**From:** [REDACTED]  
**To:** [REDACTED]  
**Cc:** [REDACTED]  
**Subject:** RE: MP06\_0258 MOD 10 Casuarina Town Centre  
**Date:** Wednesday, 31 October 2018 4:38:43 PM  
**Attachments:** [image003.png](#)  
[image004.png](#)  
[image005.png](#)  
[Open Space Dedication Plan.pdf](#)

**From:** Natasha Harras [REDACTED]  
**Sent:** Thursday, 1 March 2018 11:05 AM  
**To:** Damian Chapelle [REDACTED]  
**Cc:** Anthony Witherdin [REDACTED]; Emma Butcher [REDACTED]  
**Subject:** MP06\_0258 MOD 10 Casuarina Town Centre

CLIENT	PROJECT	TITLE
CLARENCE PROPERTY	CASUARINA BEACH	SITE LAYOUT PLAN

**BG & E**  
 PROJECT  
 CASUARINA BEACH  
 TOWN CENTRE - STAGE 2  
 CASUARINA WAY, NSW 2487

PROJECT No. B16097  
 DRAWING No. C-0003  
 REV. E

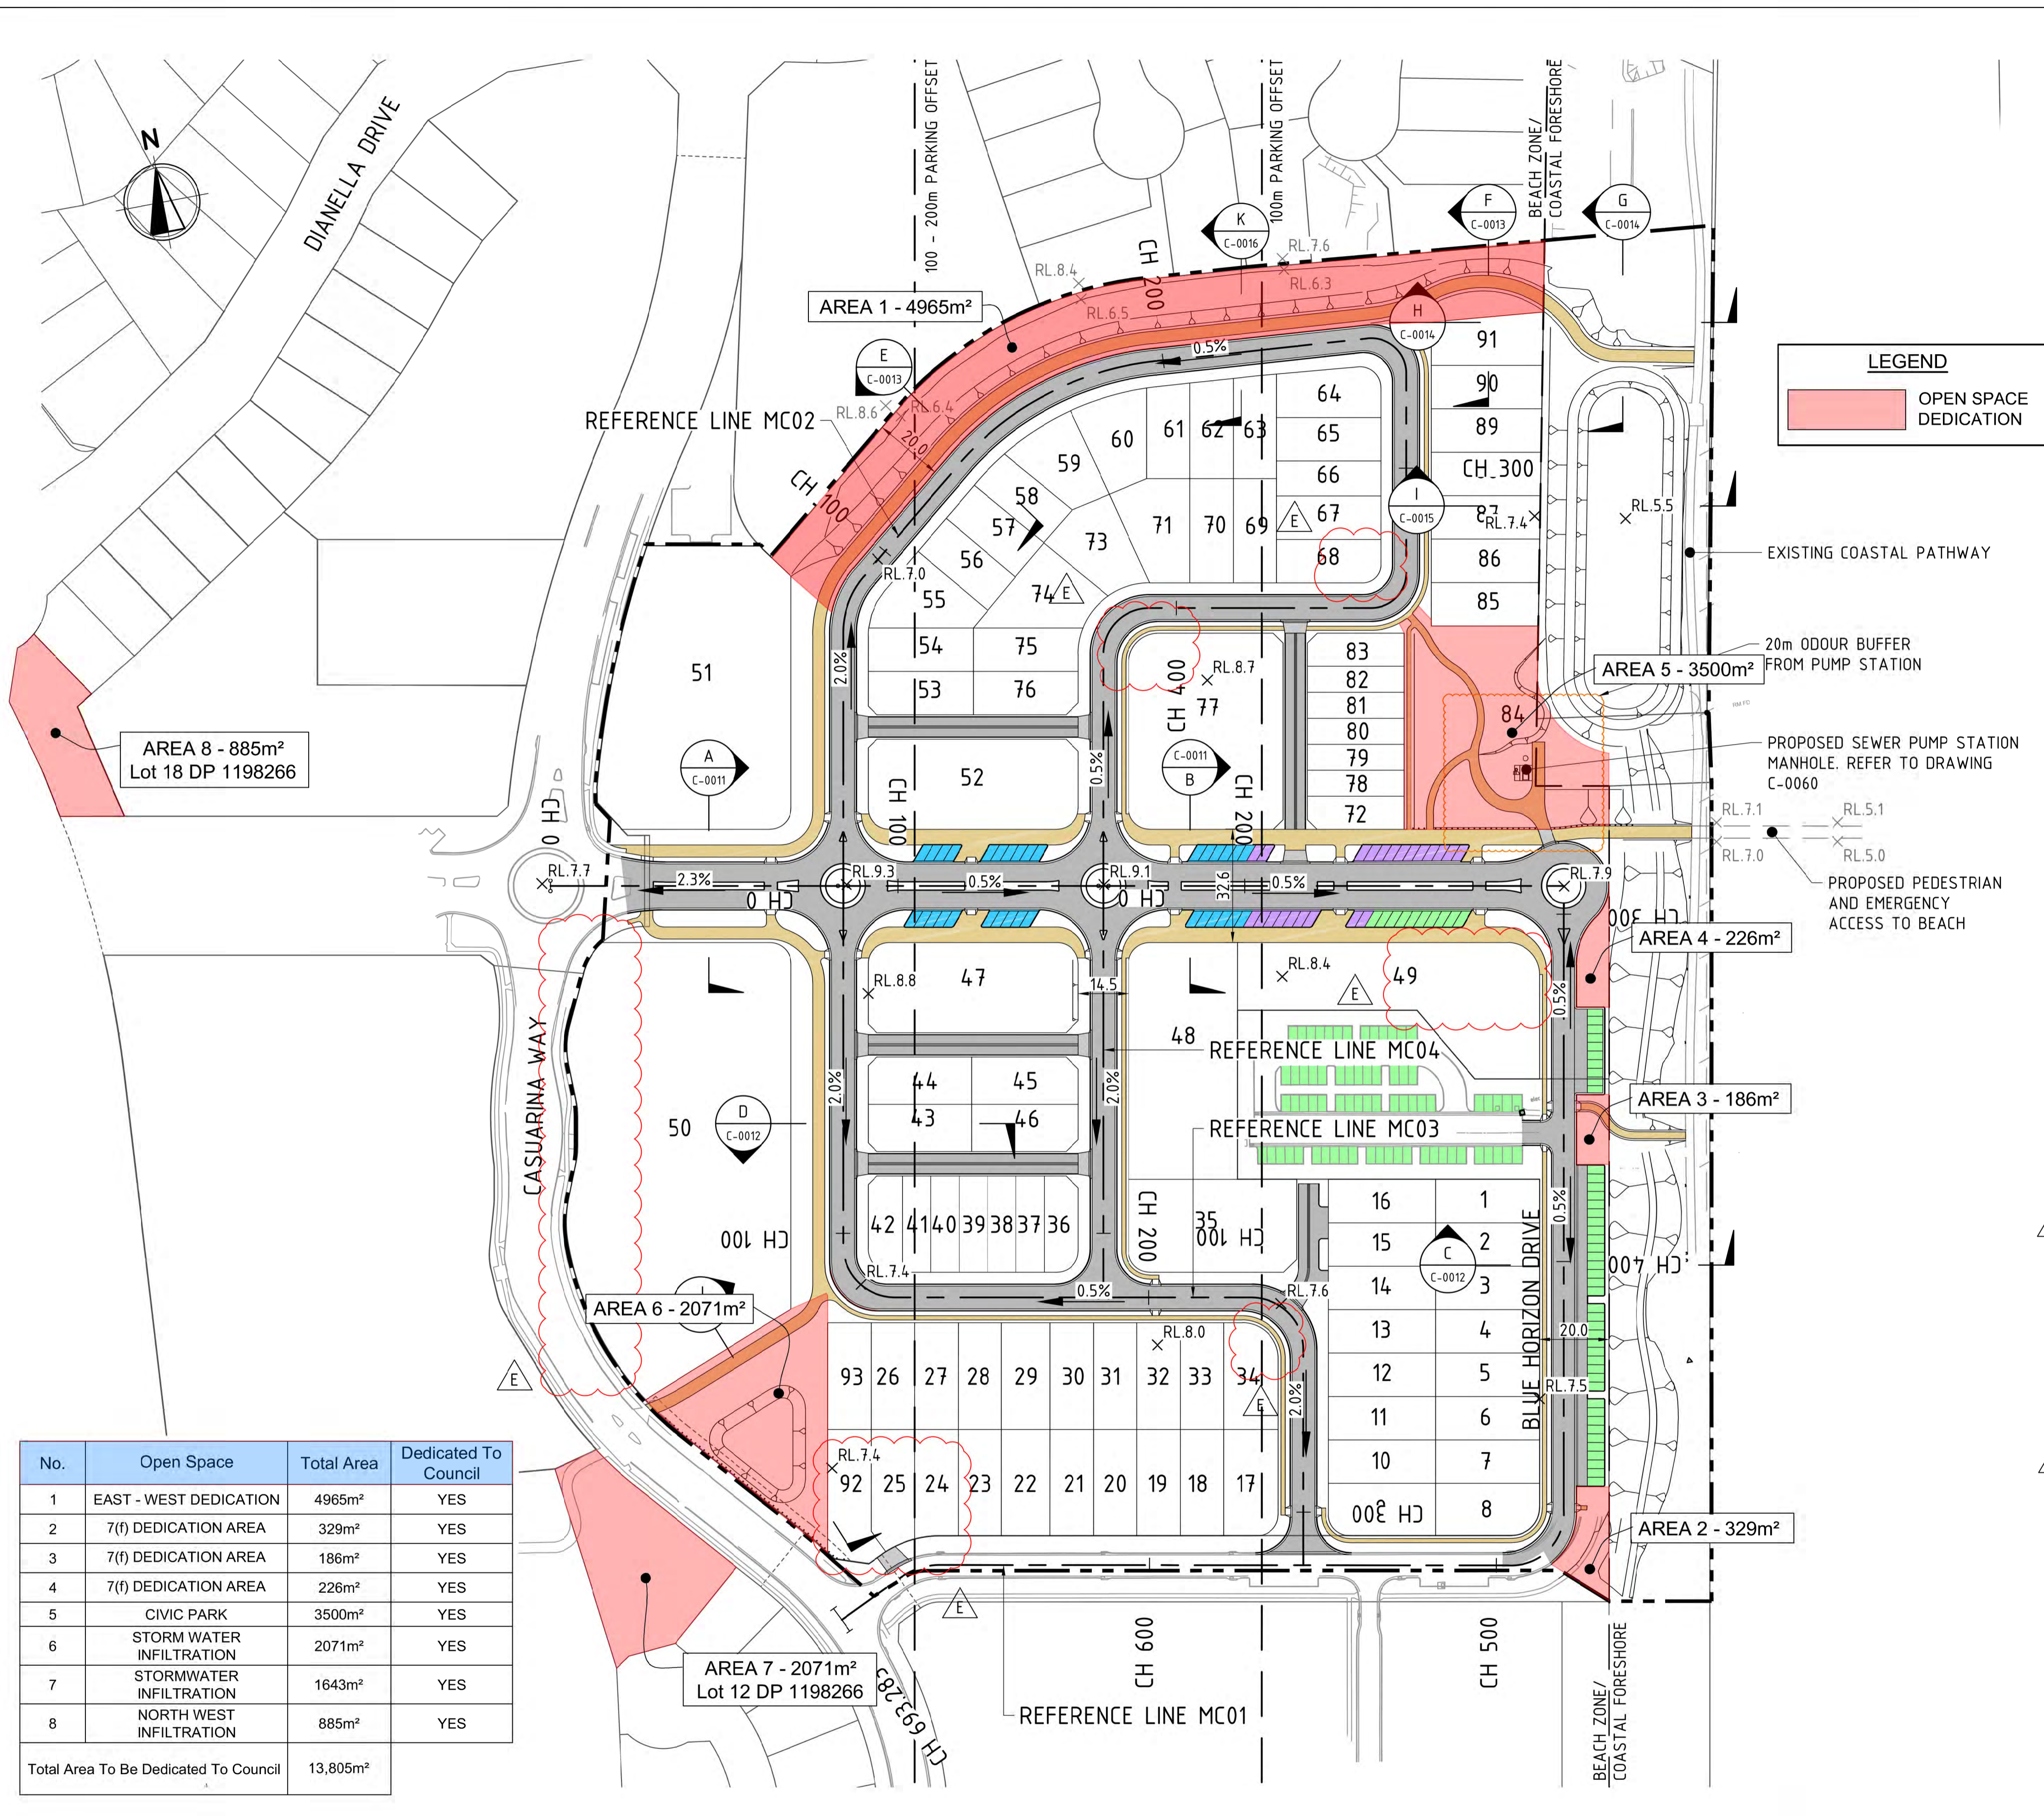
I refer the Commission to the below email from Ms Natasha Harras and the figure at the bottom of her email which clearly illustrates the total open space of 16,450sqm relates to the entire Casuarina Town Centre. I then draw the Commission to the attached BG&E Plan C-003 (Site layout Plan) which illustrates the open spaces area are provided only for the area subject to Mod 10. As a result, in stating our proposal provides 13,805sqm, this does not reflect the fact areas 4 & 6 totalling some 1,694sqm, which sits outside the Mod 10 land area has not been included in the comparison open space calculations for our assessment. That is, the open space area of 13,805sqm relates solely to the area subject to Mod 10 and not the entire Casuarina Town Centre approved under MP06\_0258. When this area is included to our proposed open space provision, a total open space dedication area of 15,499sqm is achieved. Accordingly, a reduction in open space of 951sqm and not 2,645sqm for the entire Casuarina Town Centre will result. The reduction in area is primarily as a result of the re-alignment of the cycleway.

- Please confirm that the line of the shared path through this allotment is proposed to be as per the updated Site Layout Plan C-0002 Rev E dated 1.2.18 as opposed to all other earlier plans.

Please see below the area calculation for the entire Casuarina Town centre. The area to be dedicated within Precinct B & C equates to 12,596sqm under the current approval (Areas 1, 3 & 5). The proposed modification provides for 11,297sqm (refer to attached plan & areas 1-6). The reduction is generated through the loss of the cycleway between Santai and Lot 51 and 200sqm from the civic park.

No.	Open Space	Total Area	Dedicated To Council
1	EAST - WEST DEDICATION	4965m <sup>2</sup>	YES
2	7(f) DEDICATION AREA	329m <sup>2</sup>	YES
3	7(f) DEDICATION AREA	186m <sup>2</sup>	YES
4	7(f) DEDICATION AREA	226m <sup>2</sup>	YES
5	CIVIC PARK	3500m <sup>2</sup>	YES
6	STORM WATER INFILTRATION	2071m <sup>2</sup>	YES
7	STORM WATER INFILTRATION	1643m <sup>2</sup>	YES
8	NORTH WEST INFILTRATION	885m <sup>2</sup>	YES
<b>Total Area To Be Dedicated To Council</b>		<b>13,805m<sup>2</sup></b>
